Pentium[®] II Processor Specification Update

Release Date: February 11, 1998

Order Number: 243337-011

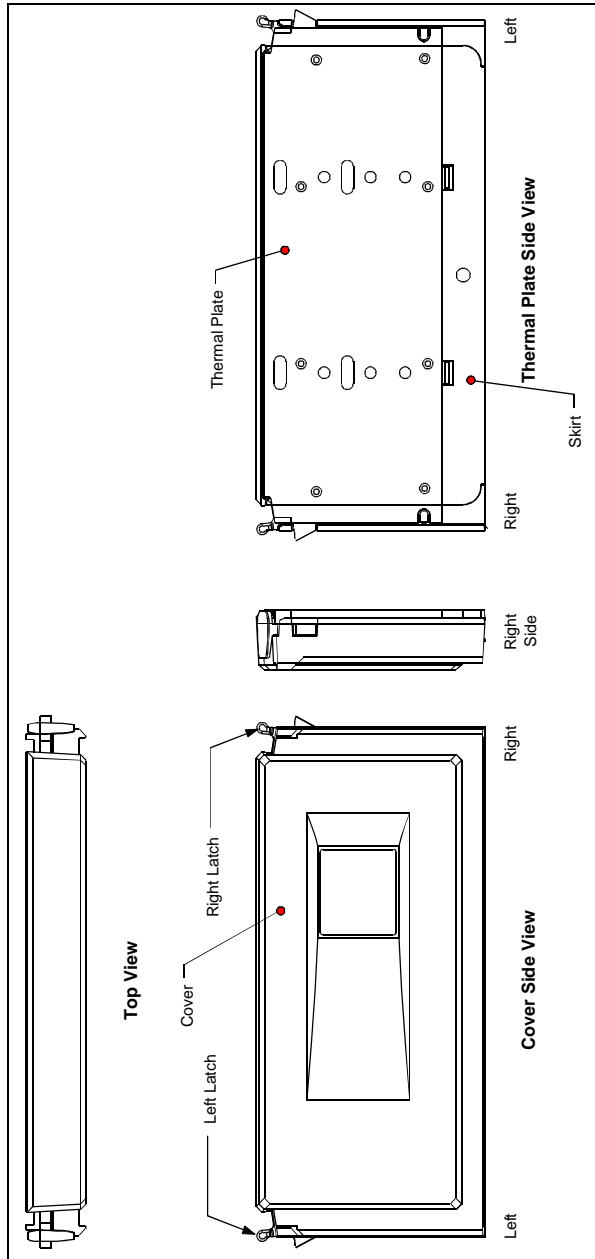
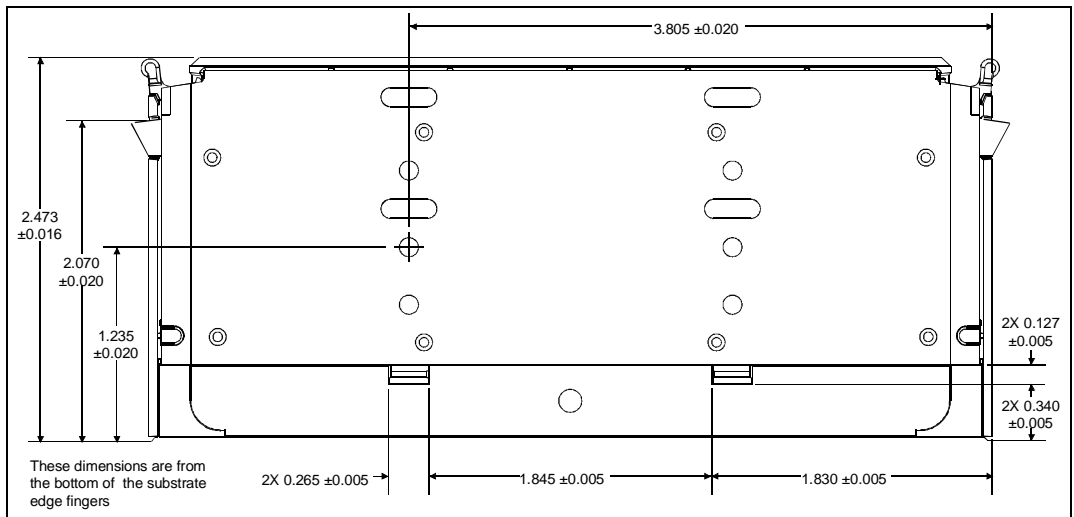
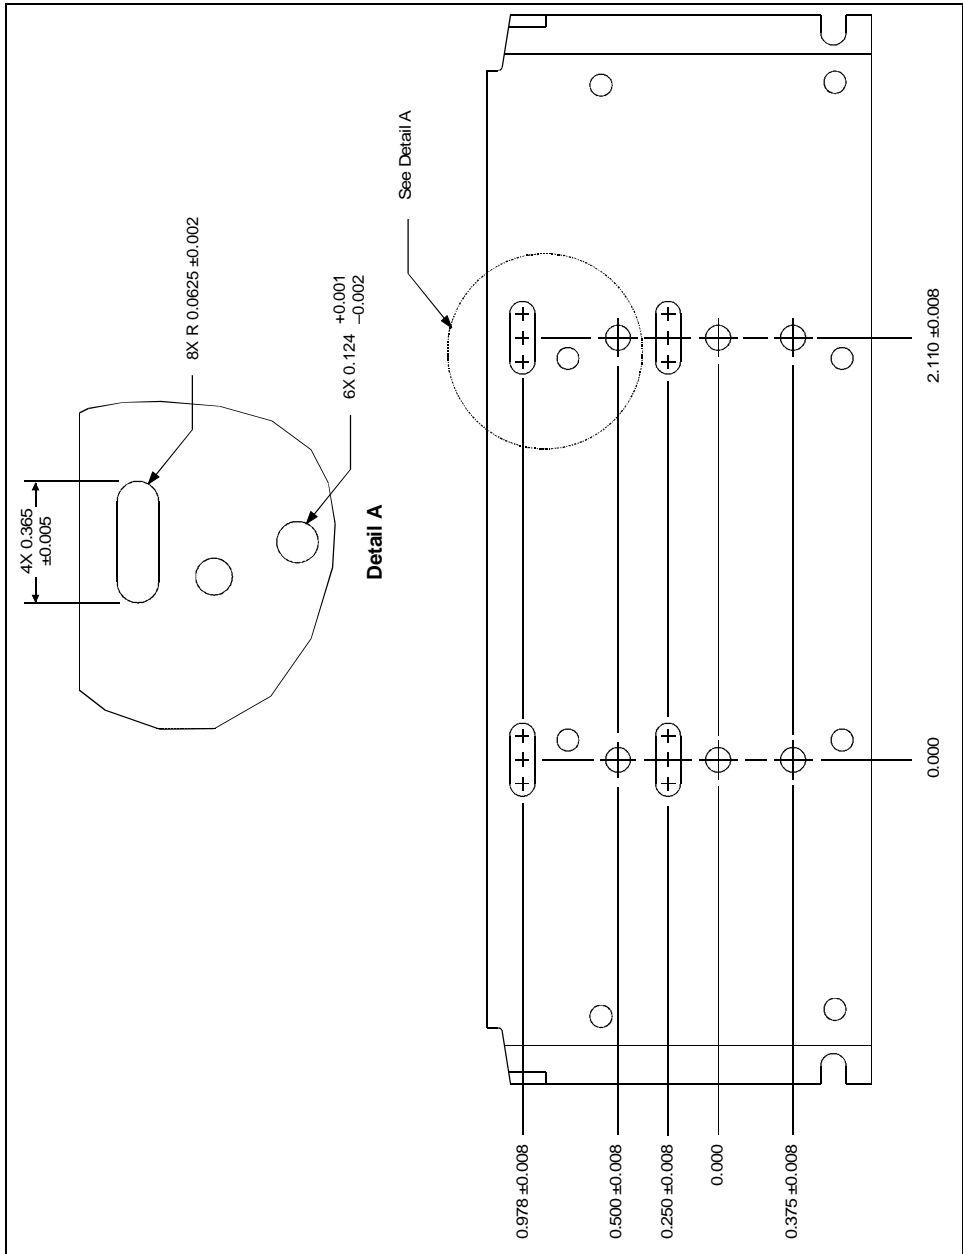
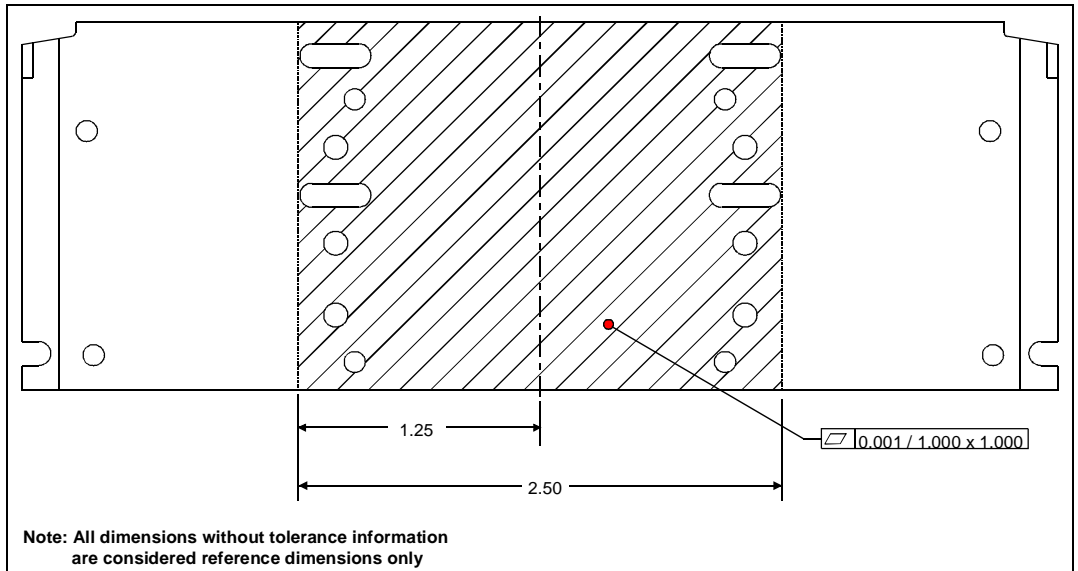
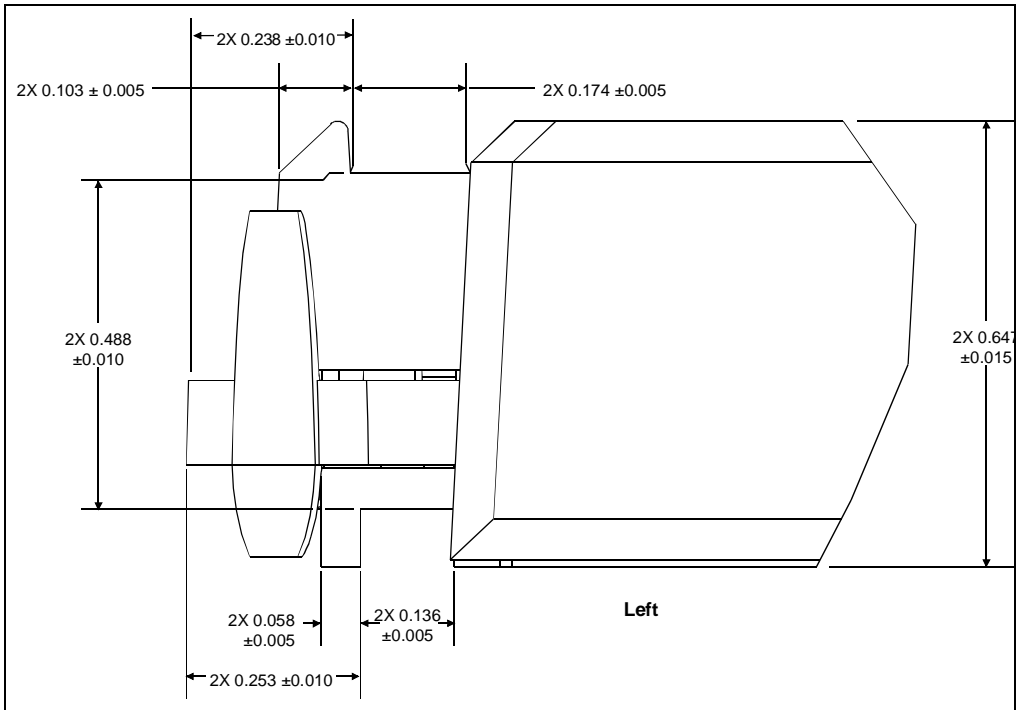
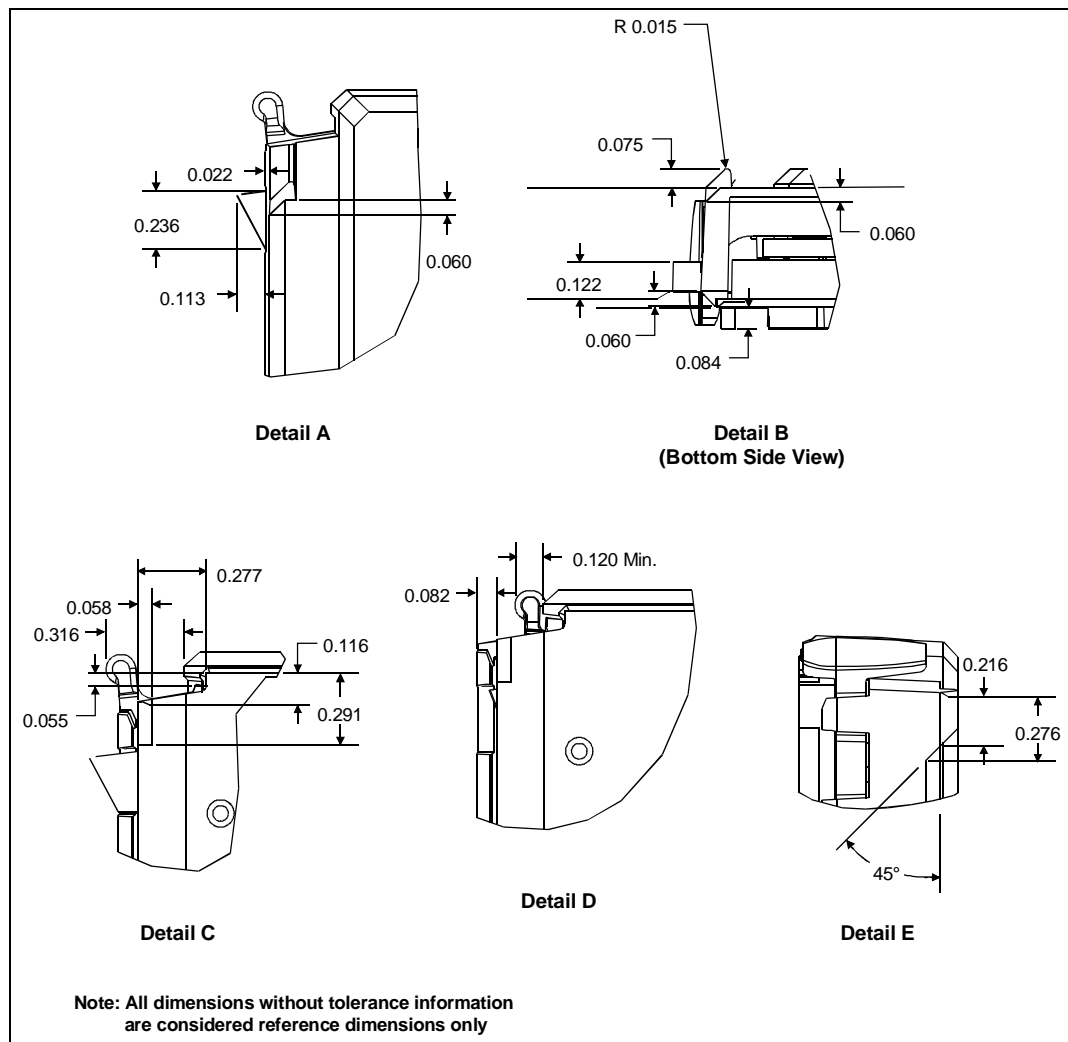
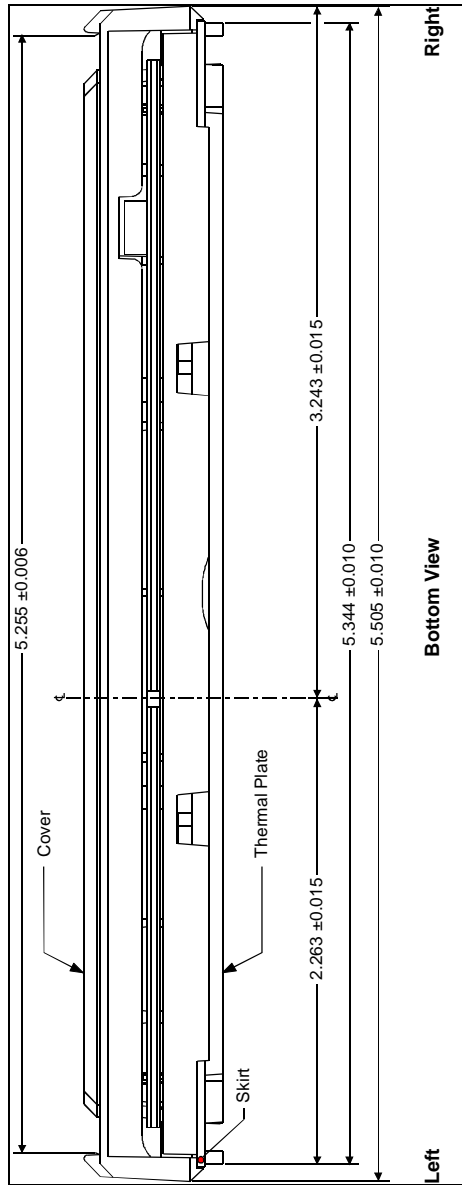
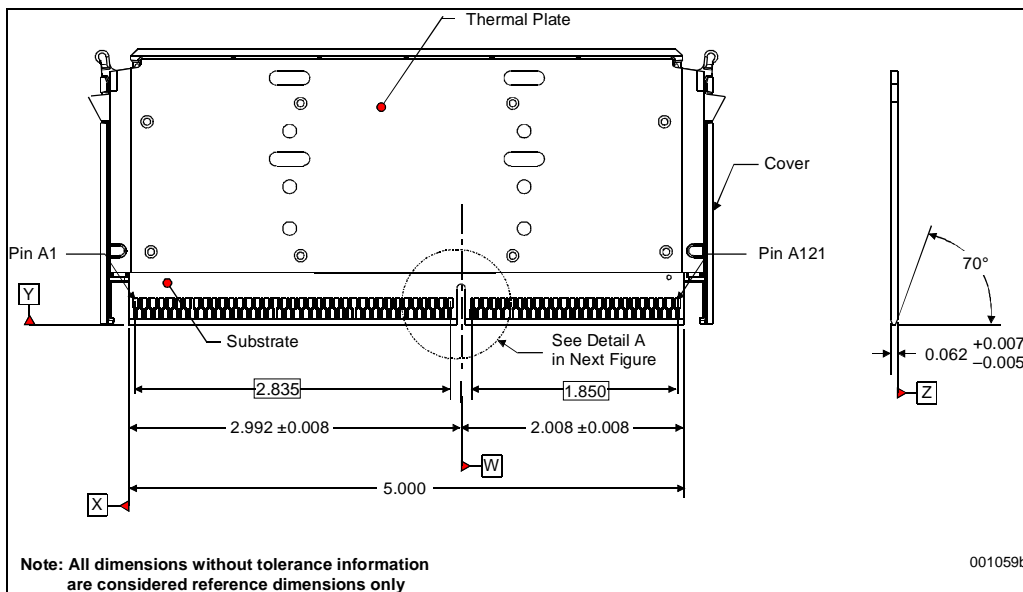
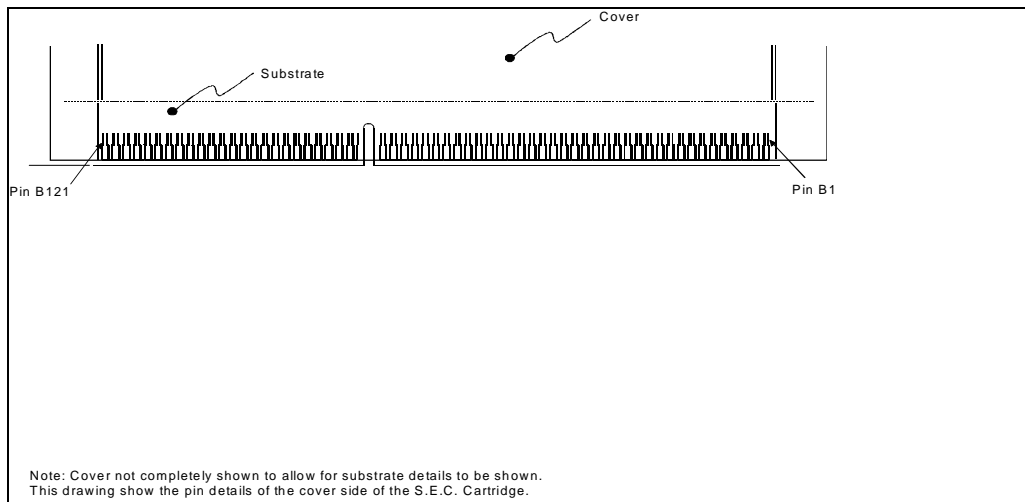
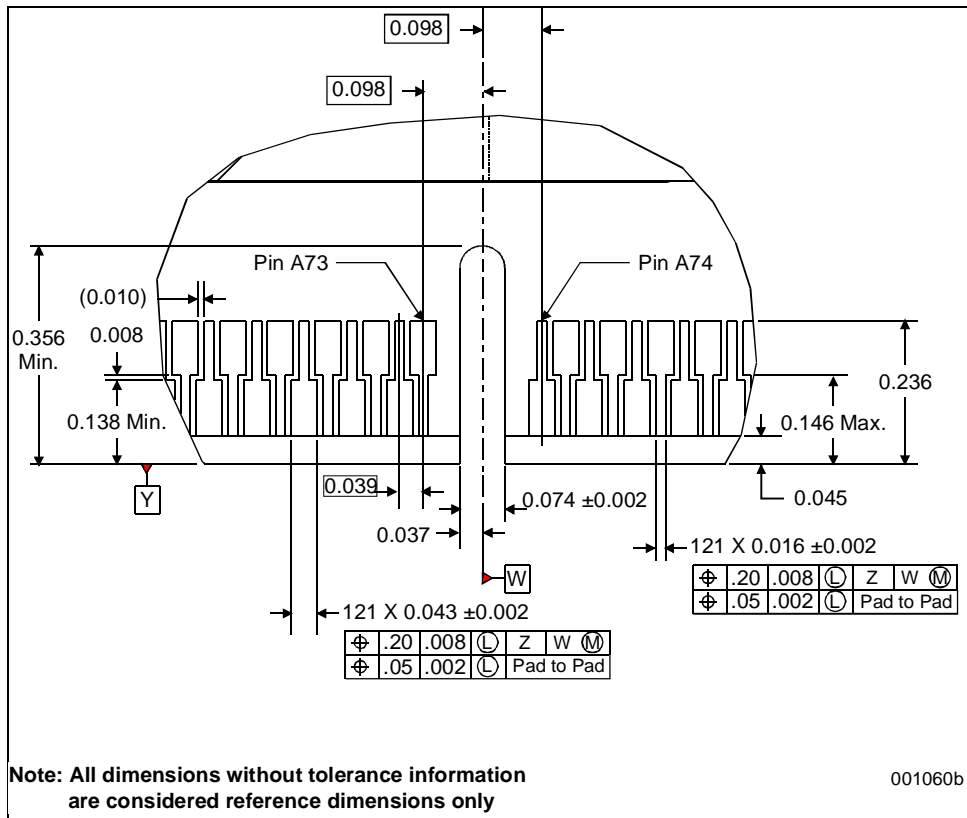
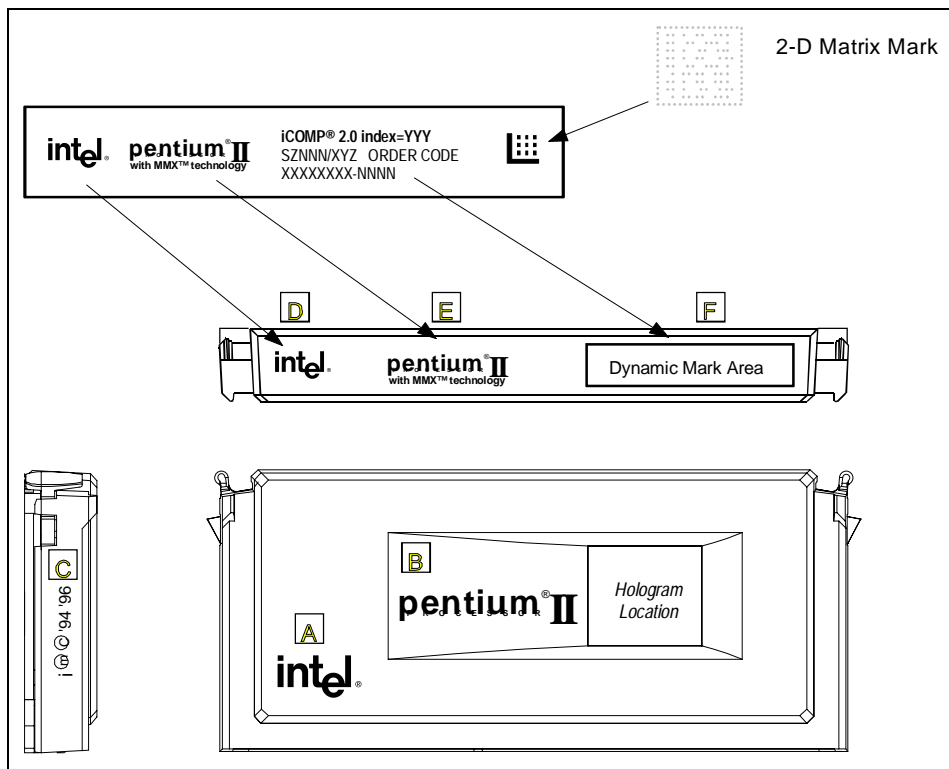
The S.E.C. cartridge mechanical specifications provided in the *Pentium® II Processor at 233 MHz, 266 MHz and 300 MHz* datasheet contained incorrect tolerance information for some dimensions. Also, some of the information provided in the figures was duplicitous and not required to accurately use and design for the S.E.C. cartridge package. The revised figures provided in this section are meant to replace Figures 29 through 42, Table 23 and the accompanying notes found on page 44.

Figure 12. Heatsink Attachment Mechanism Design Space

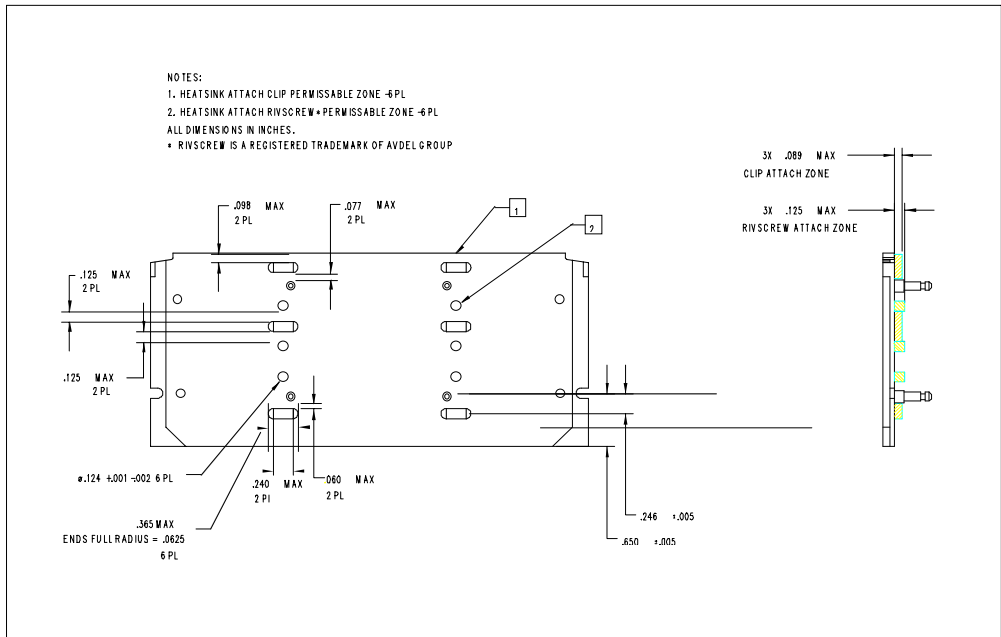
A change to the attach mechanism specification is provided below. The original specification for clearance of heatsink attach solutions is provided in Section 4.3. (and Figure 23 and Figure 24) in the *Pentium® II Processor at 233 MHz, 266 MHz and 300 MHz* datasheet. Figure 11 shows the revised maximum specifications for heatsink clip and RivscREW* attach mechanism designs. All heatsink clip and RivscREW attachment solutions must remain within the respective maximum “permissible” zone as detailed in Figure 11.

The thermal plate shown in Figure 11 is used to portray the heatsink attach mechanism design space for the future Slot 1 processors. However, the maximum “permissible” design space is also valid for both the current Pentium II and future Slot 1 processors.

Please review the proposed specifications to guarantee compatibility with existing Pentium II and future Slot 1 processor heatsink attachment solutions. Note that the required heatsink attachment solution space should not exceed the maximum proposed design space while installed or during the installation and removal procedure.
